Modification Recommended Service Note

N8924A - Autoranging System DC Power Supply, 750V, 20A, 5000W, 208 VAC

Serial Numbers: DE14290000 - DE15369999 without manufacturing ID Version "B"

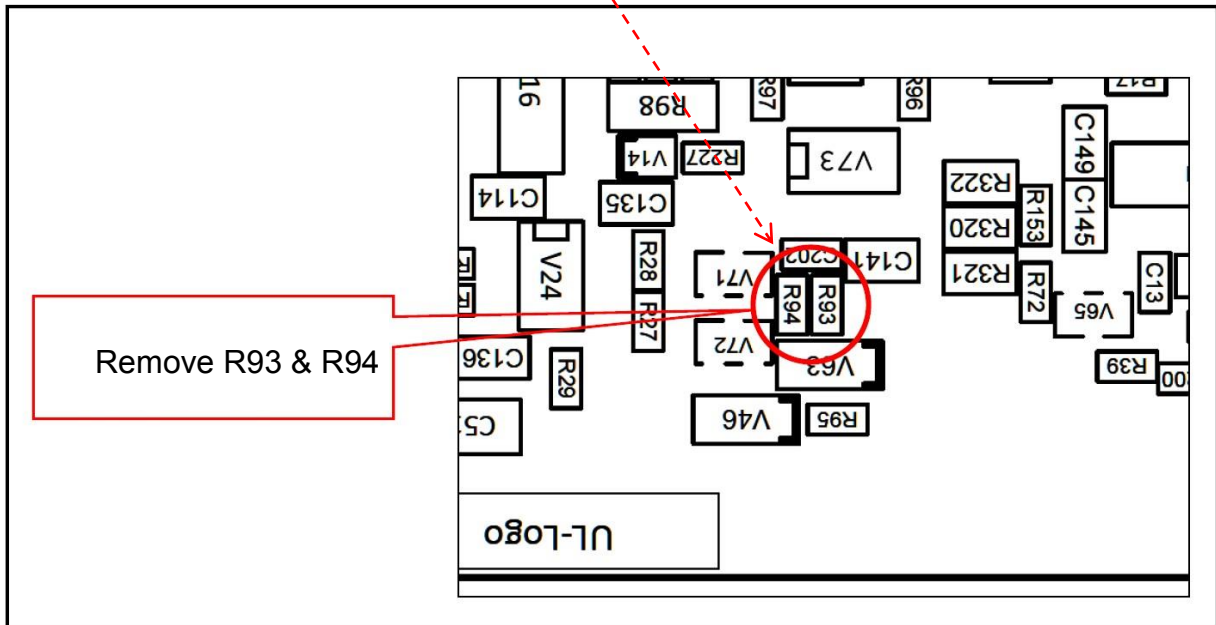
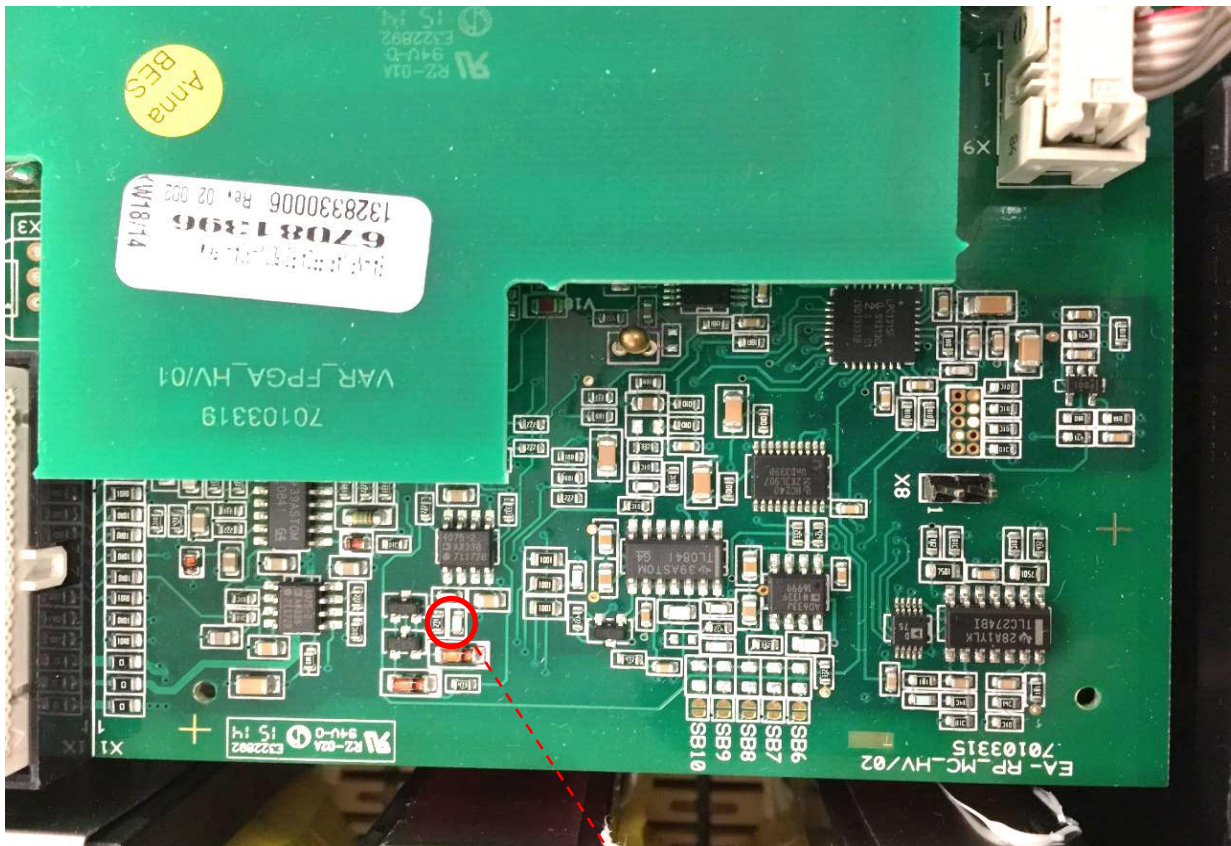
- 1) Remove acMains cable from power source.
- 2) Wait 5 minutes
- 3) Remove top cover from instrument.
- 4) In the 5kW units (viewed from the front of the unit), a small SMT assembly located at the right-rear of instrument will be readily visible (see below):

In the 10kW & 15kW units; although found in the same location, a black plastic cover will have to be removed to gain visibility and access to the SMT assembly. Plastic cover snaps-on and can be removed with a small screwdriver.

5) SMT resistors R93/94 are located in red circle shown below:

Removal of two (2) surface mount resistors, R93 and R94, will correct this problem:

6) After removal of R93 & R94, re-install all covers. Instrument does NOT require recalibration after the removal of R93 & R94.

Suffix "B" added

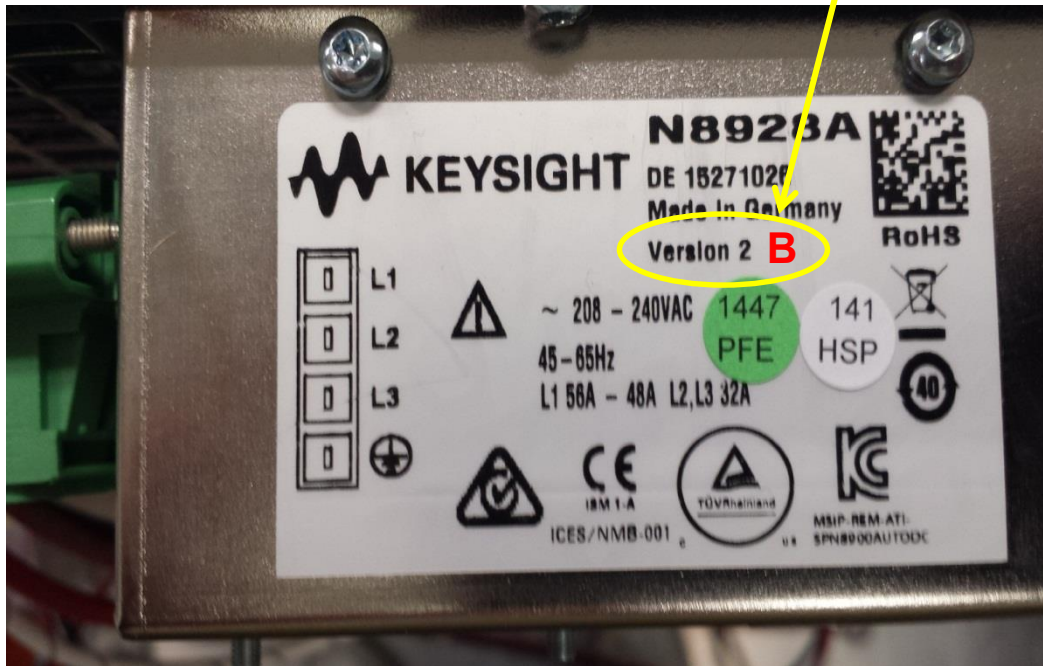
7) On the acMains label, on the rear of the instrument; use an indelible marker, to add the suffix letter "B" after the Version ID. This will assist in the tracking of modified instruments.
